ON-SITE SEWAGE DISPOSAL SYSTEM HOWARD COUNTY HEALTH DEPARTMENT BUREAU OF ENVIRONMENTAL HEALTH

SUBDIVISION: Edgewood Farm LOT NUMBER: 16

ADDRESS: 14629 Cory's Court PROPERTY OWNER: Toll MD V LP

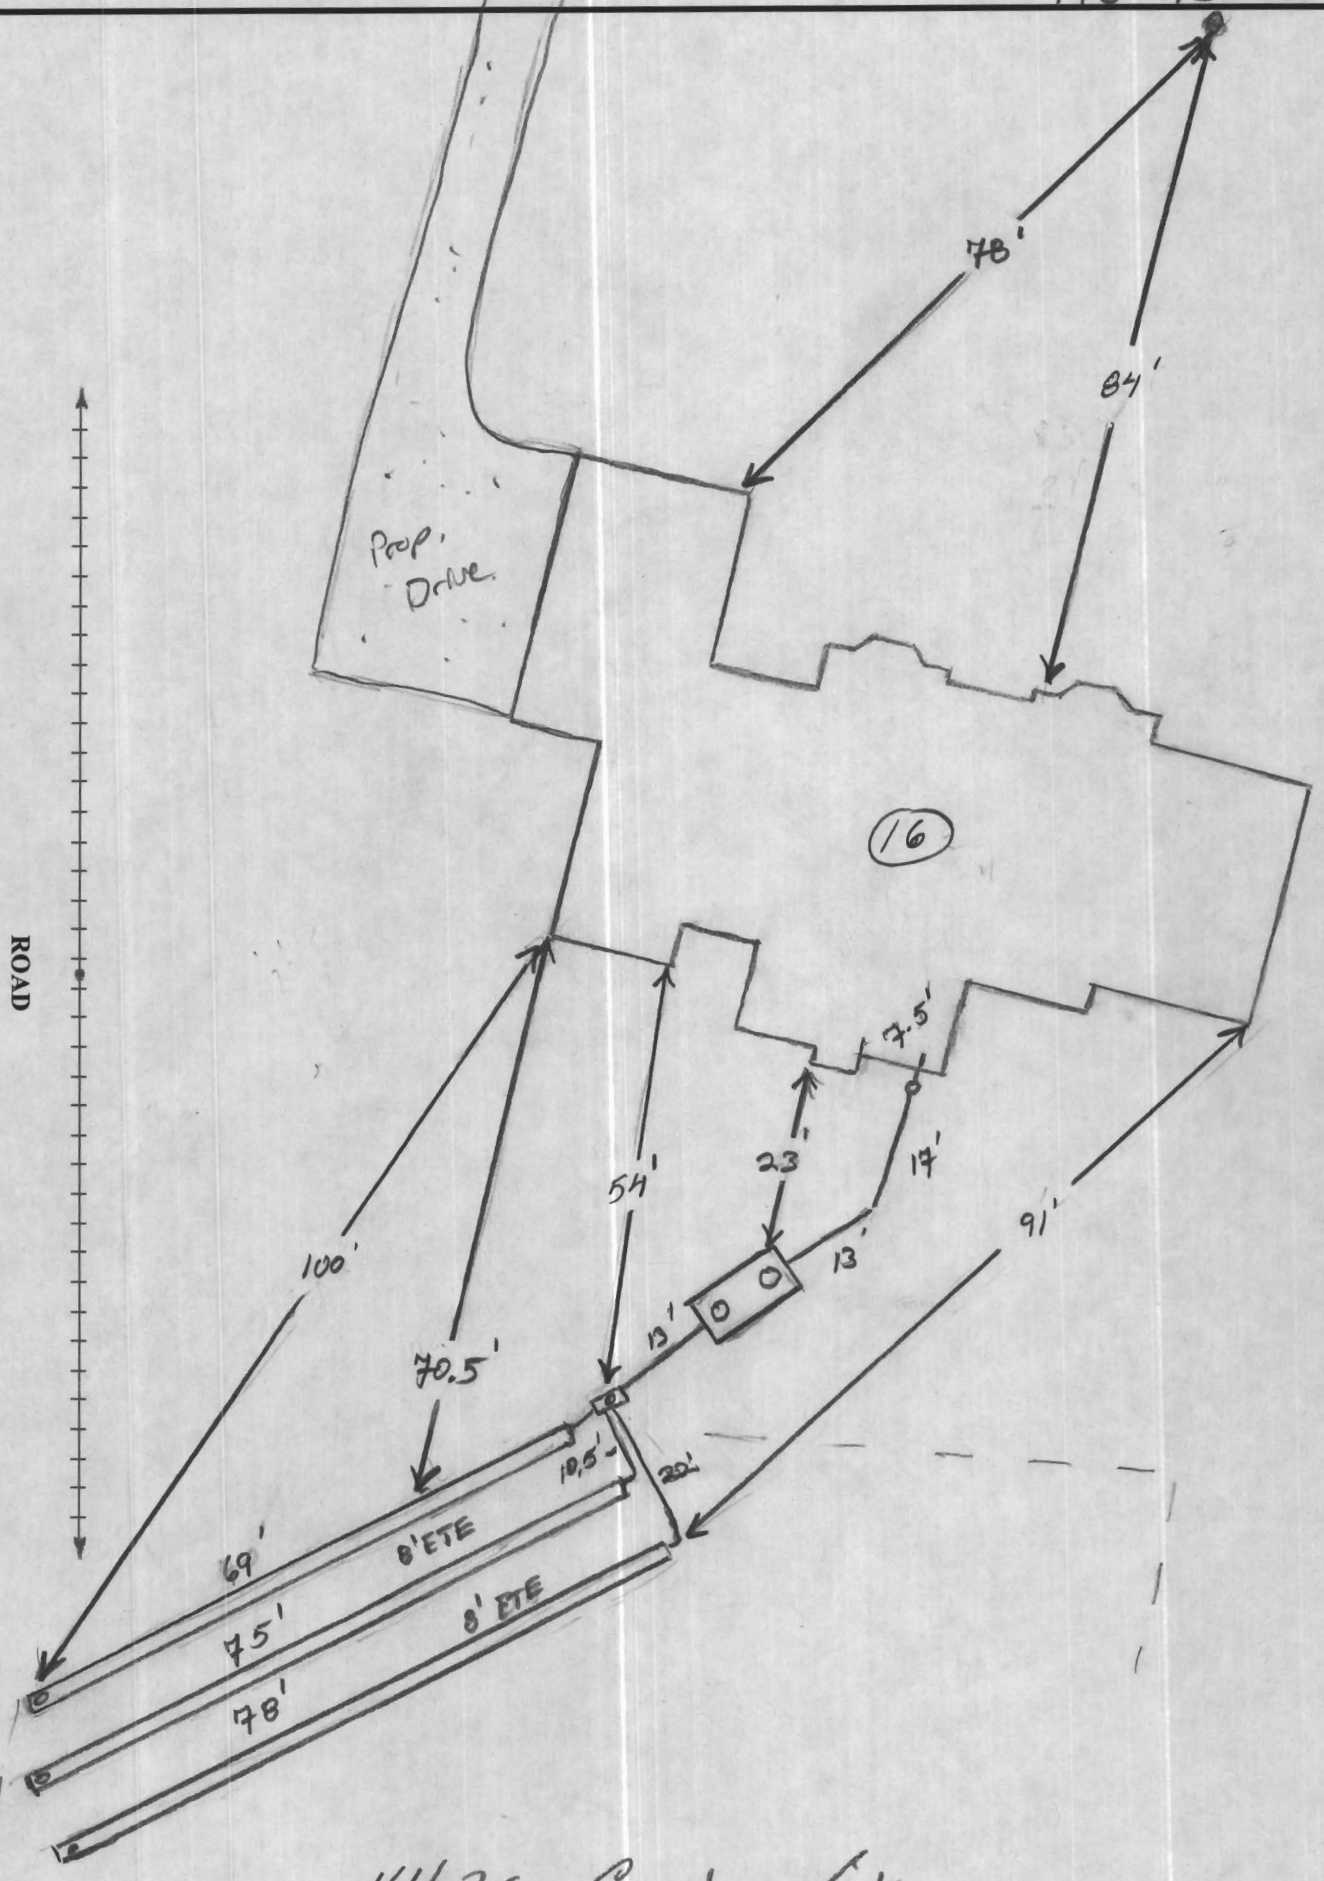
PRE-CONSTRUCTION 12/27/07 set tank 20' from dwelling.

set D box @ top middle part of SDA, run 3 & 73'

INSTALLATION trenches on contour towards left lot line. (KW)

1/22/08 Everything installed except for top trench.

Trenches look good. Digging top trench now. 8' bottoms.

Need map of top trench before backfill. OK to

backfill everything else. D box will need to be leveled. (KW)

1/22/08 (p.m.) Top trench finished. D box leveled. OK to

backfill. (KW)
